Project Name: Willow - Bid Package 2 – New Build

Project No.: 221125-090

Architect: Kingscott

This Addendum is issued to inform the bidders of modifications in the scope of work being bid for this project.

SHEET TITLE
**FOUNDATION PLAN
UNIT 100**

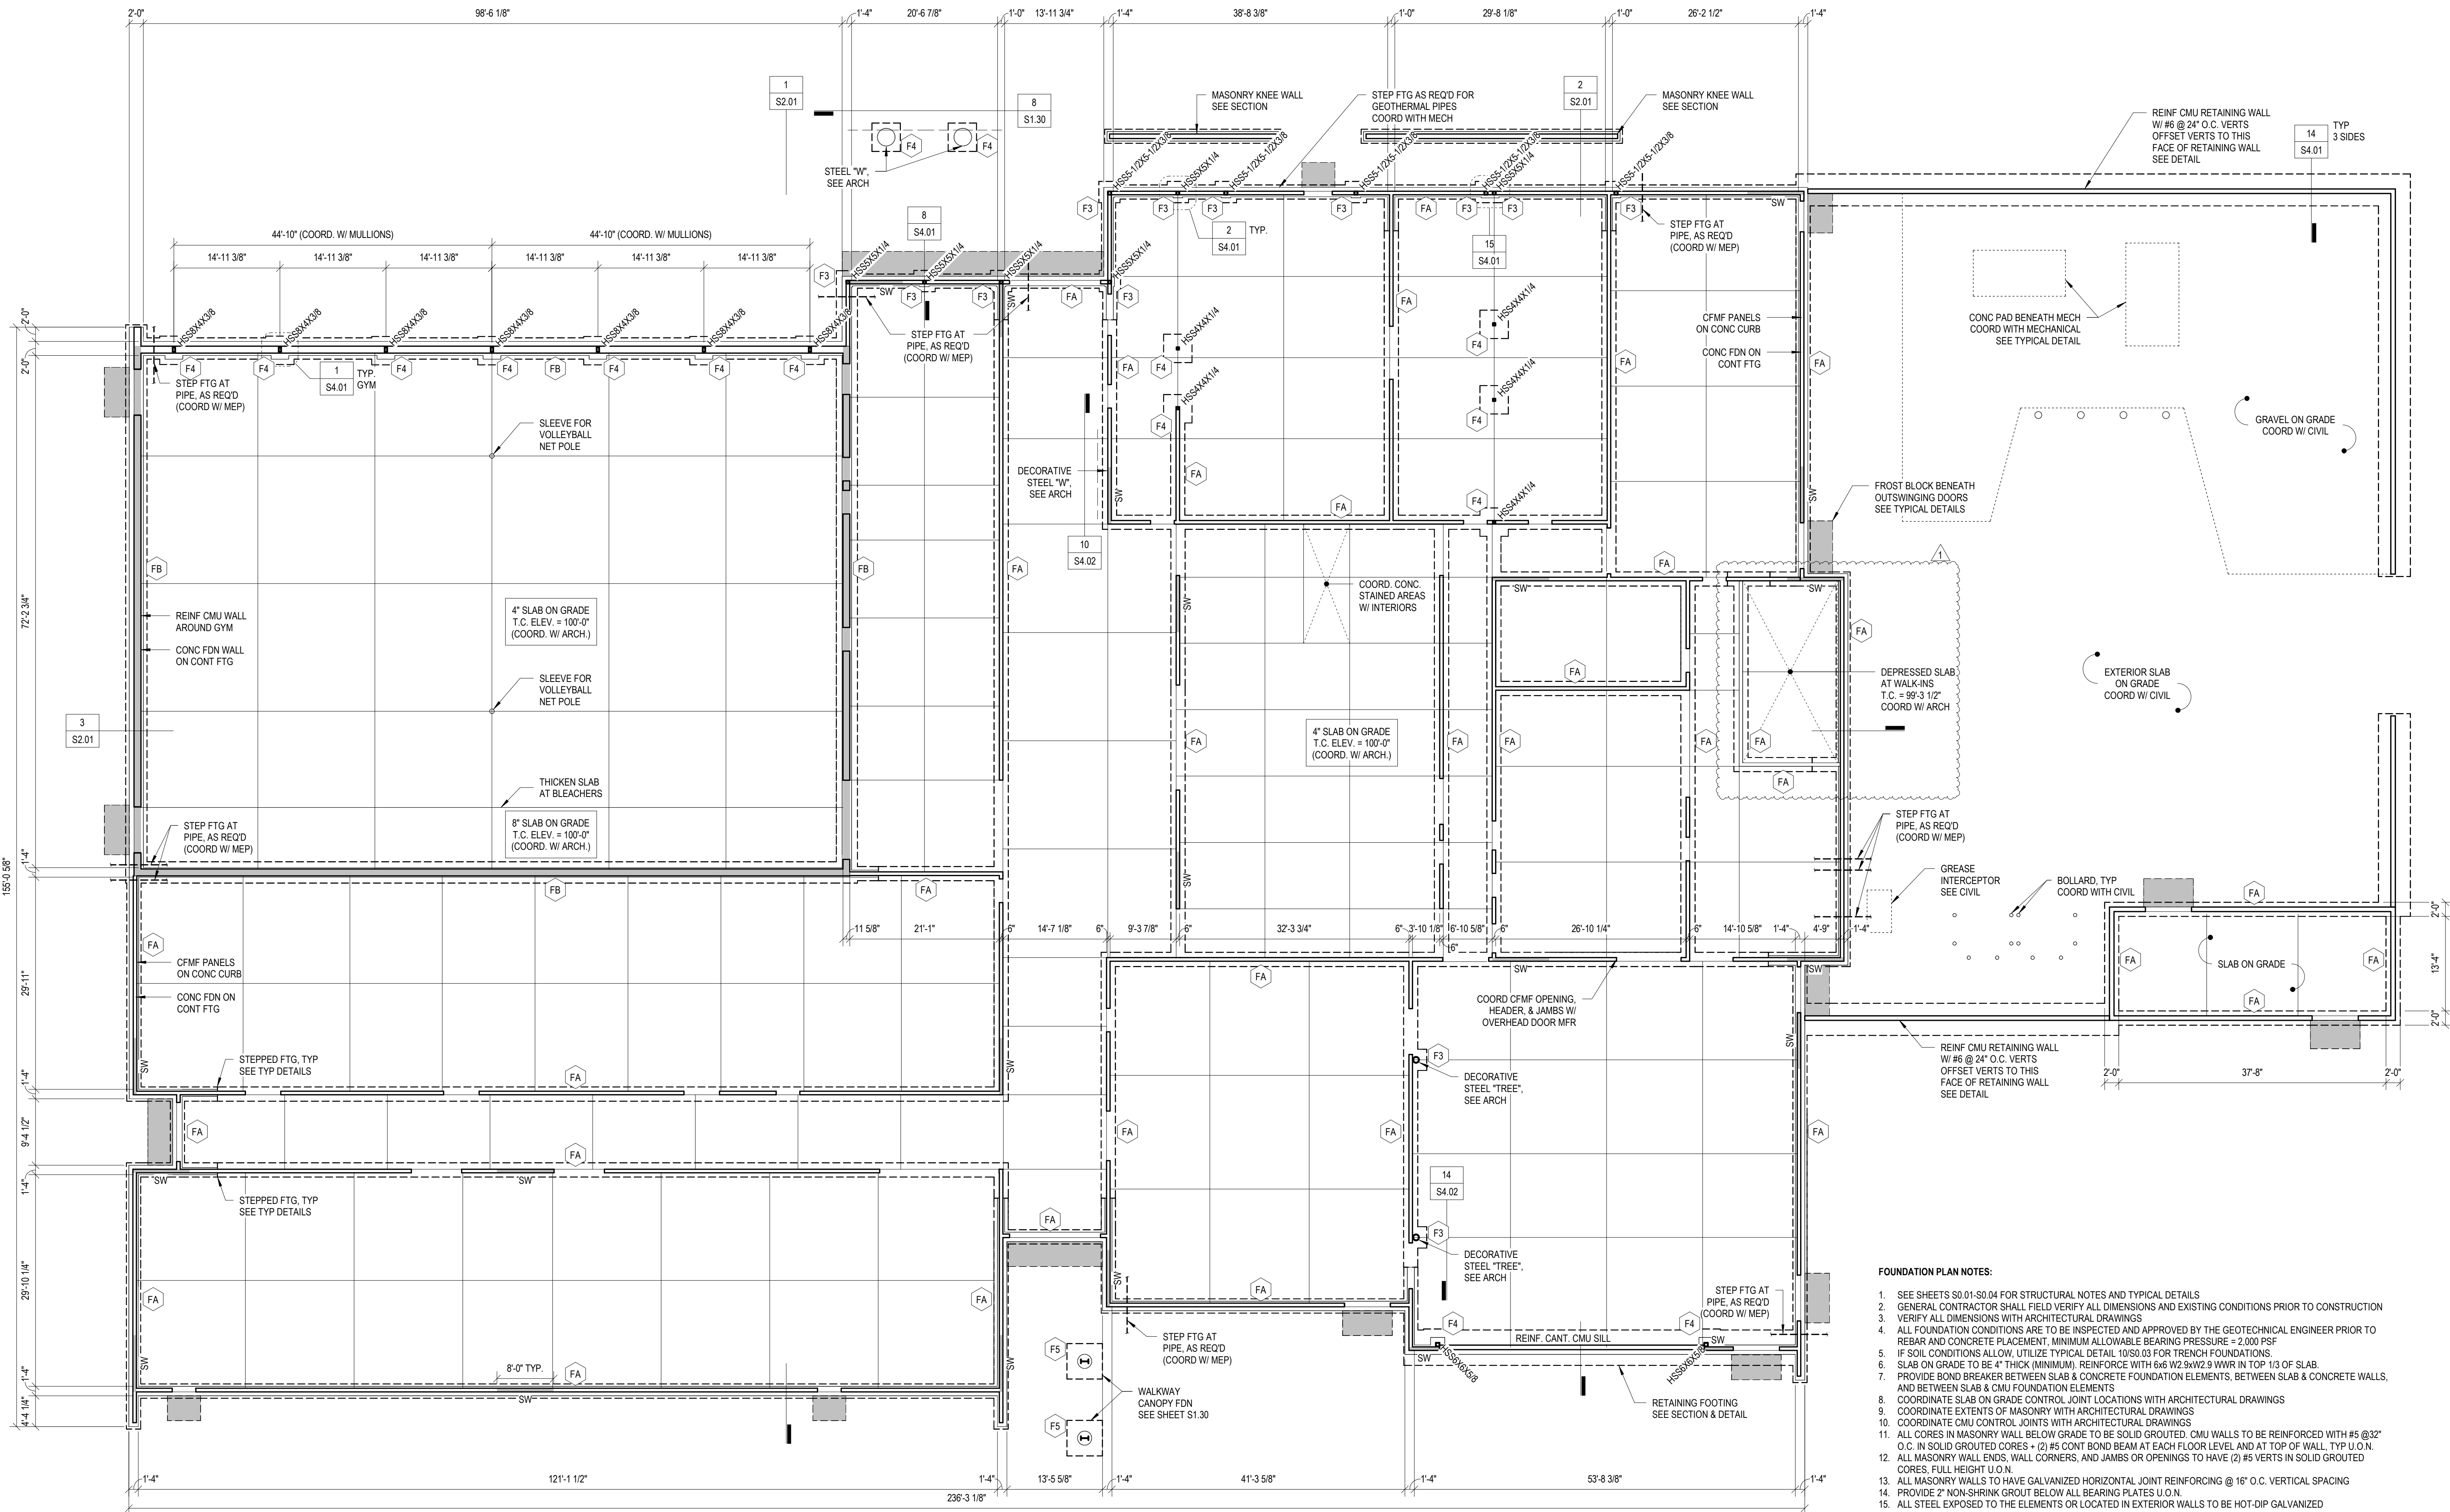
- Revised footing schedule “F5” to be top and bottom each way, hooked ends.
- Shifted kitchen walk-in cooler to the west and changed slab depression from 8” to 8 1/2”.

SHEET TITLE
FOUNDATION PLAN
UNITS 200, 300, 400

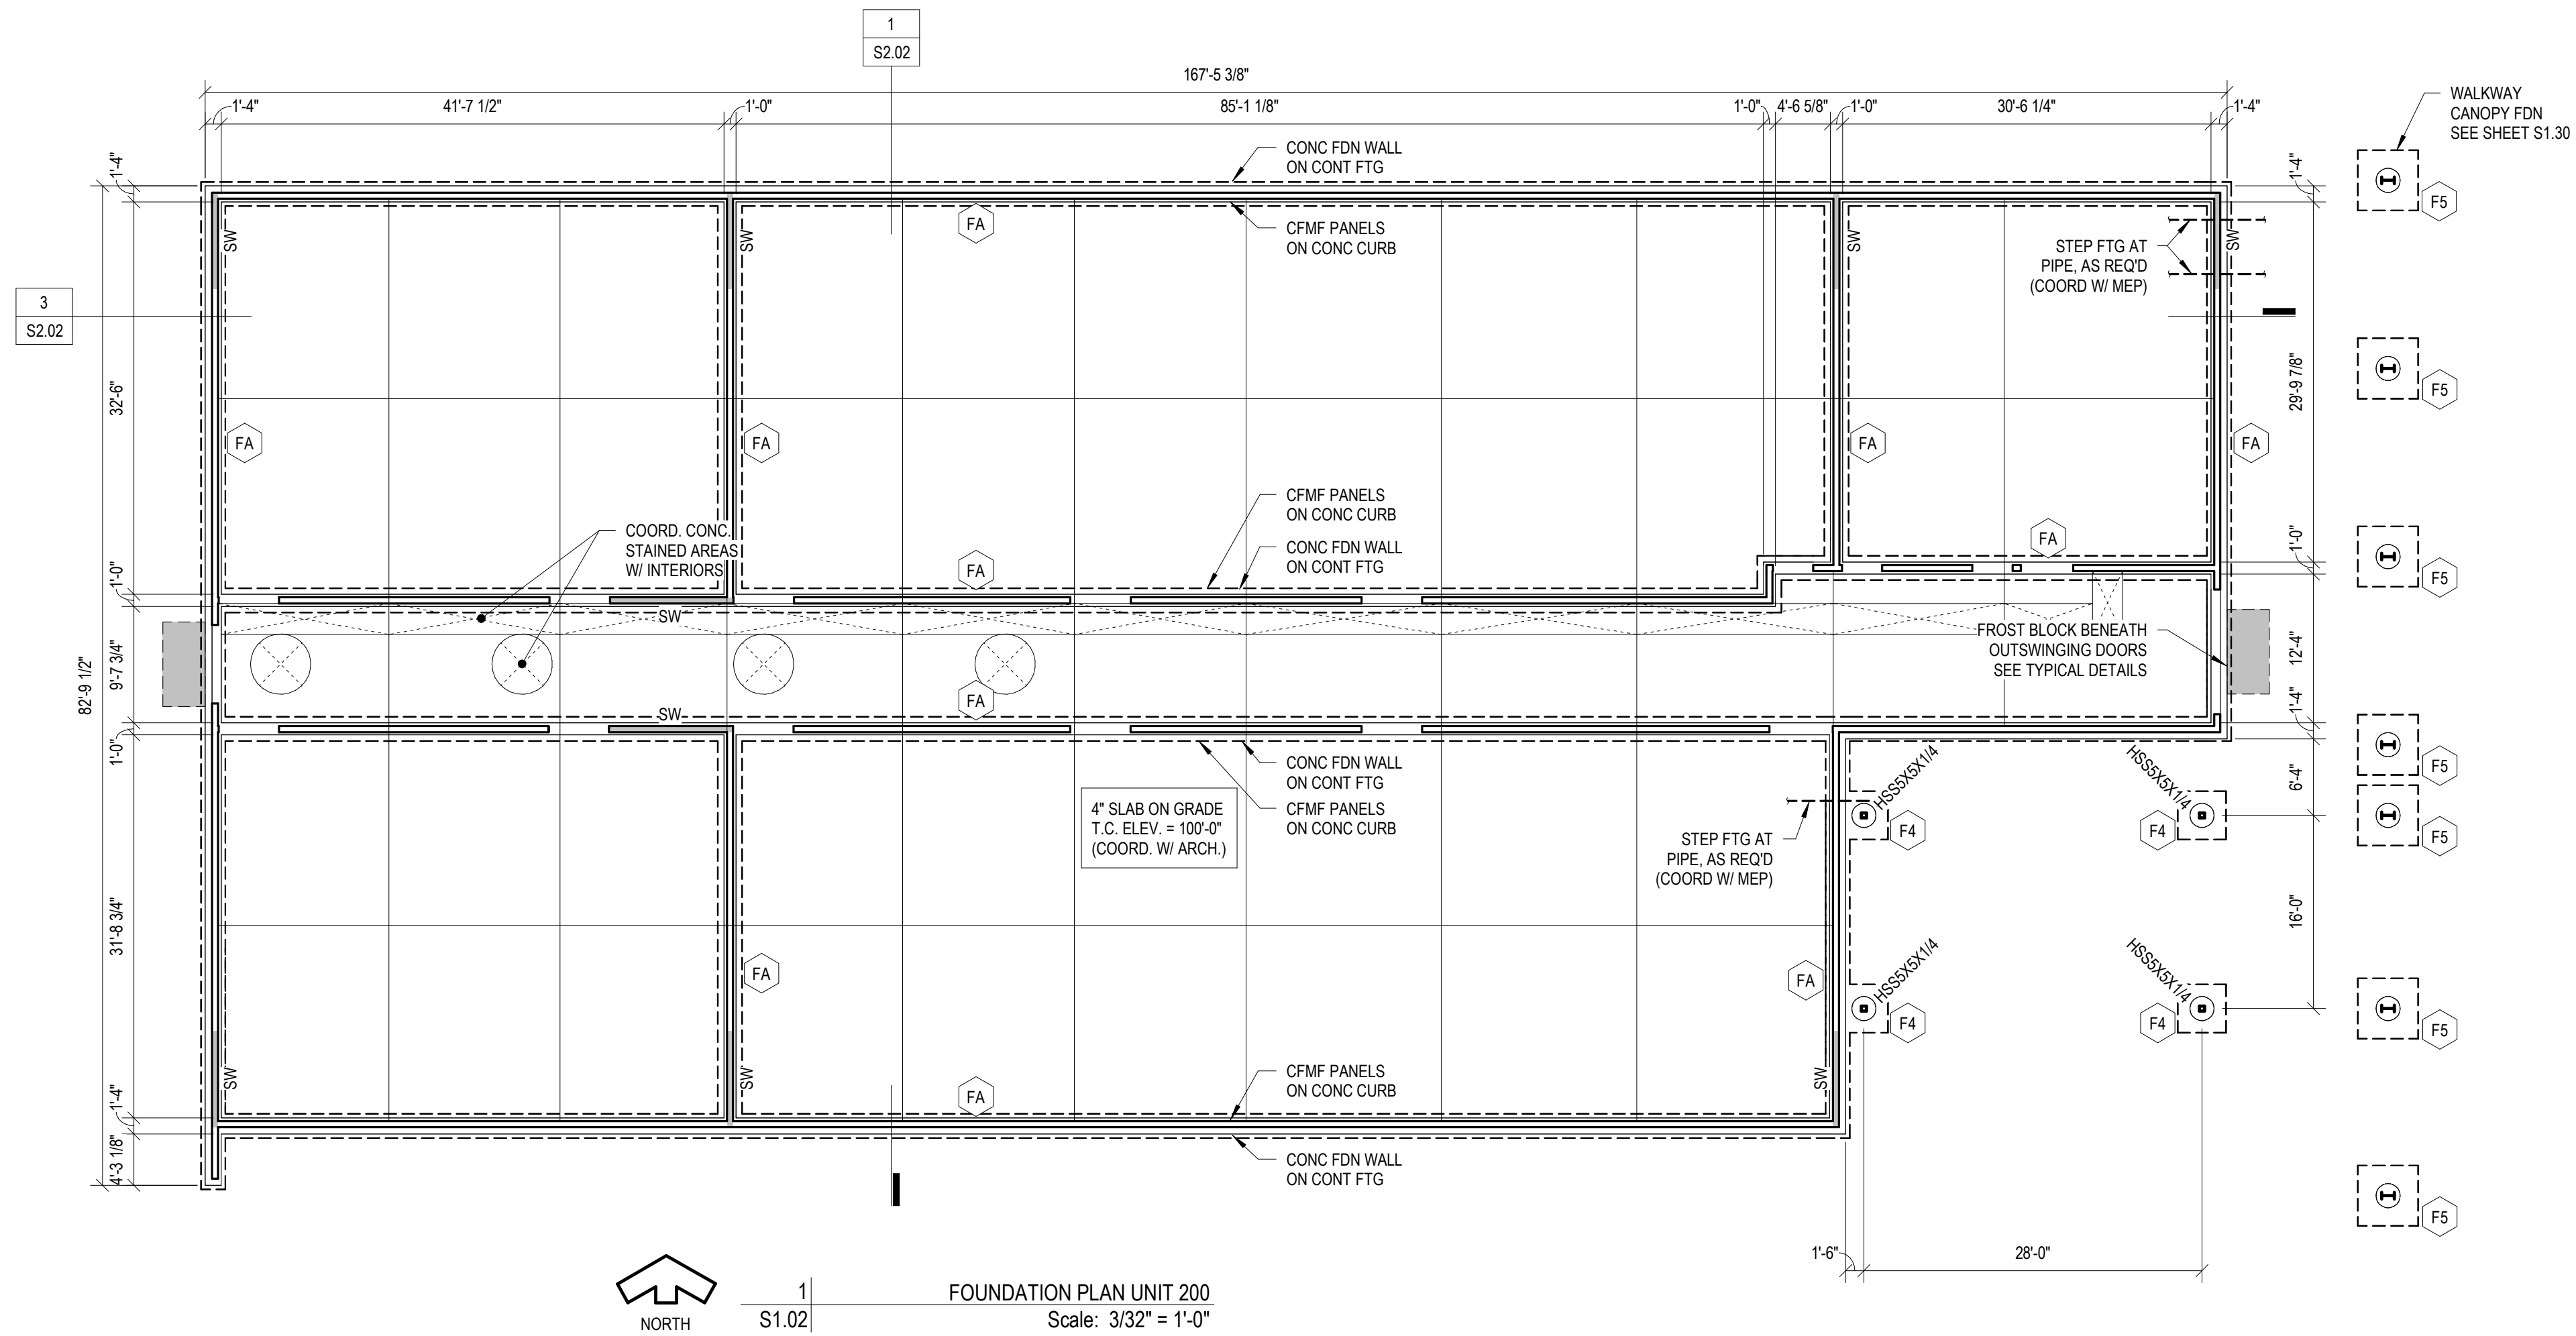
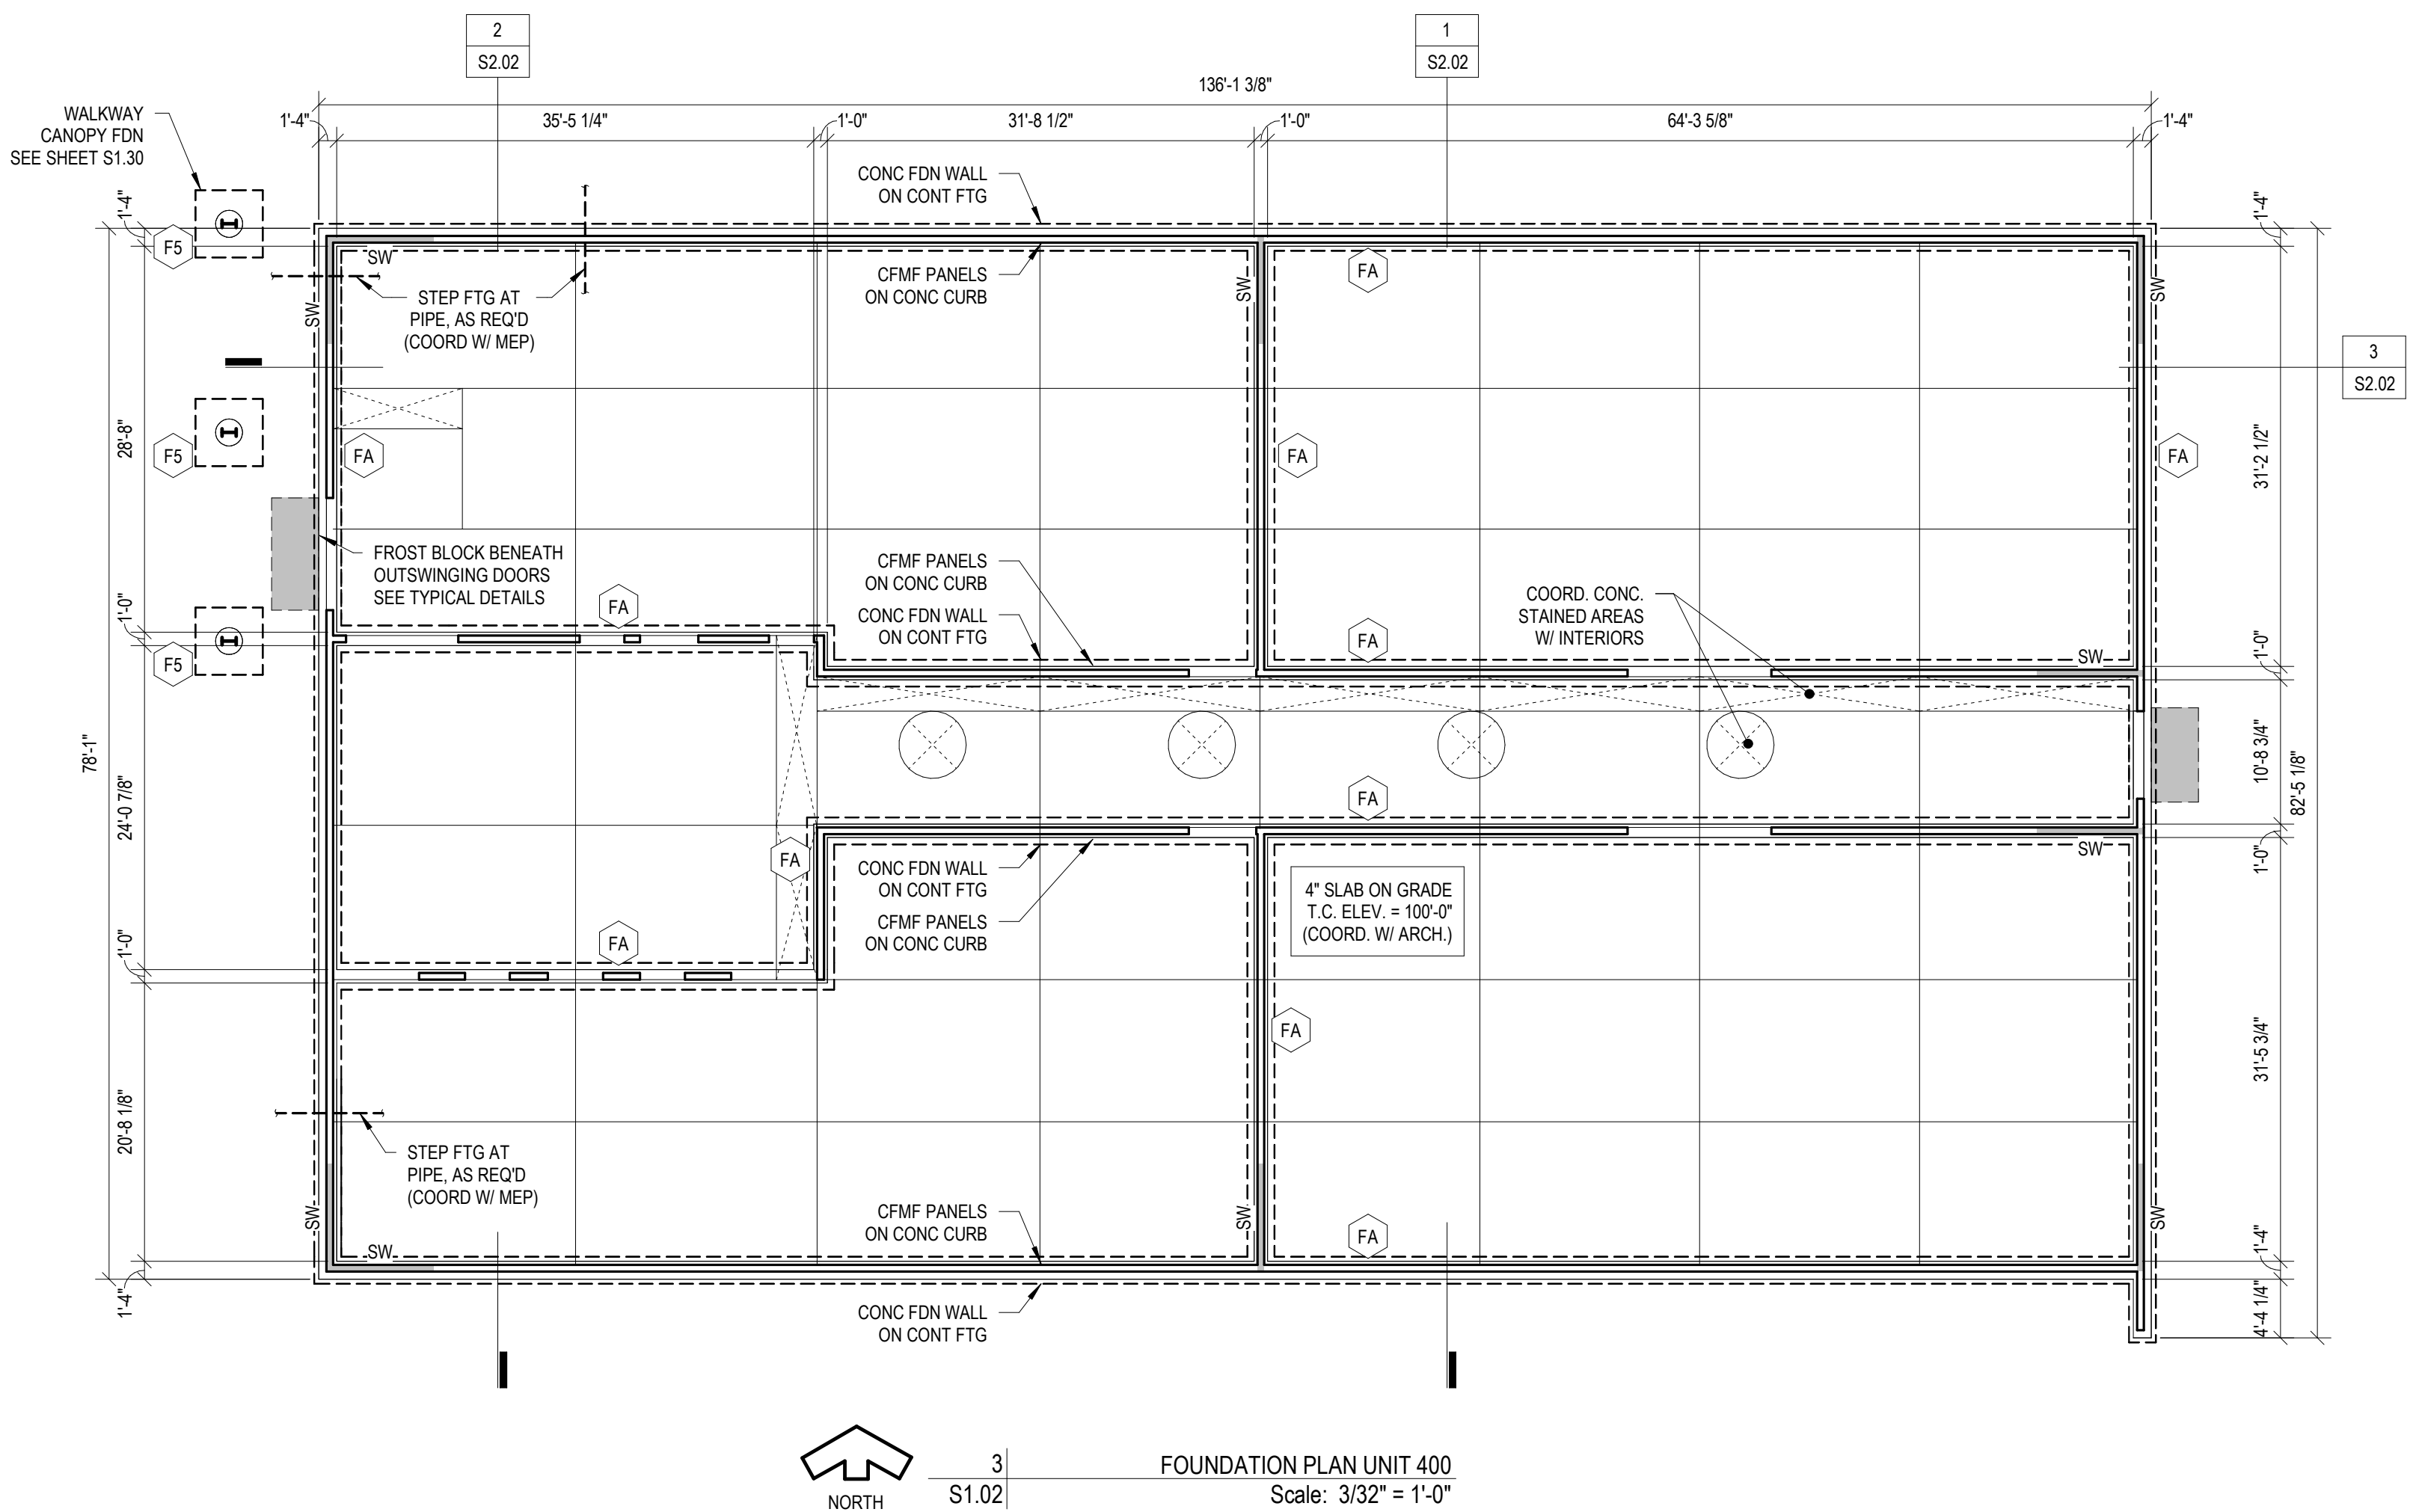
- Revised footing schedule “F5” to be top and bottom each way, hooked ends.
